Determination 2015/028

Regarding the authority's refusal to grant building consent and whether proposed alterations to an existing building at 1 Warwick Street, Blenheim comply with the Building Code in respect of fire safety

Figure 2: Floor plan indicating alterations (not to scale)

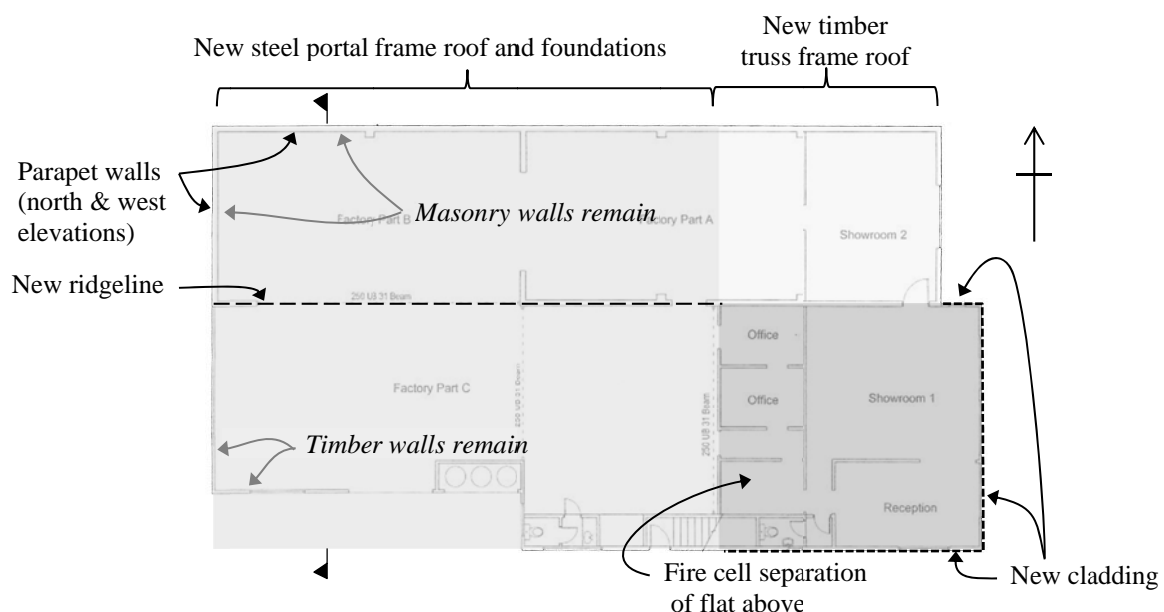
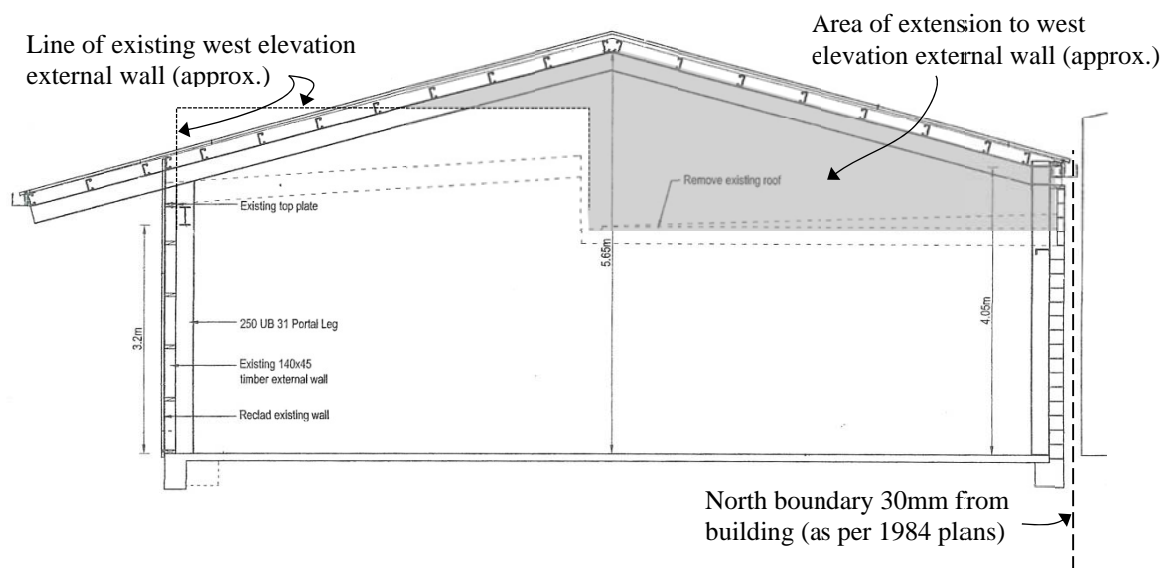
- The alterations appear to extend the fascia of the building over the north boundary.
- No provision in the documentation submitted for consent to:
 - fire rate the new sections of wall above the existing boundary walls where the height has increased

- replace or modify the framing on the west boundary walls up to the new roof so that the framing is supported between structural elements
 - fire rate part of the workshop roof adjacent to the upper level (as proposed to the showroom ceiling in the fire report)

- demonstrate how the fire rating is provided to the flat or will be achieved around the deck and the existing partitions to establish the flat as a separate firecell

- detail fire rating requirements where the external cladding is being altered.
- The change to the roof structure above the showroom, in conjunction with the proposed fire rating to the wall between the flat and showroom, impacts on natural light and ventilation compliance to the two bedrooms.

- Passive protection*
- 6.2.9.3 The proposed alterations include building work to make the flat a separate fire cell as well as fire rating work to the showroom ceiling to satisfy the requirements of clause C4 of the Building Code. Notwithstanding the difficulty of achieving fire separation as a retrofit, I can accept that the provision of this separation could be achieved as near as is reasonably practicable provided that the fire ratings proposed to the showroom ceiling on the north side of the flat are extended to the workshop to west

side. The documents provided in support of the building consent application do not currently provide sufficient information to illustrate how the separation will be achieved and provide assurance that this will be adequate.

- The new building work will not fully comply with the Building Code as required by section 17 of the Act as follows:
 - The fire ratings required to the new sections of wall above the existing walls.

- The fire rating to the north and west boundary walls to prevent horizontal spread of flame.
- There is insufficient and/or unclear information in the consent documentation to establish that the new building work will comply fully as required by section 17 of the Act as follows:

- The fire ratings required to the new primary elements to provide structural stability to walls required to fire rated.
 - The extent to which the existing timber framed wall on the western boundary requires modification (either by replacement, or by other means) to provide for stability to enable the fire rating of the new wall above to be achieved.
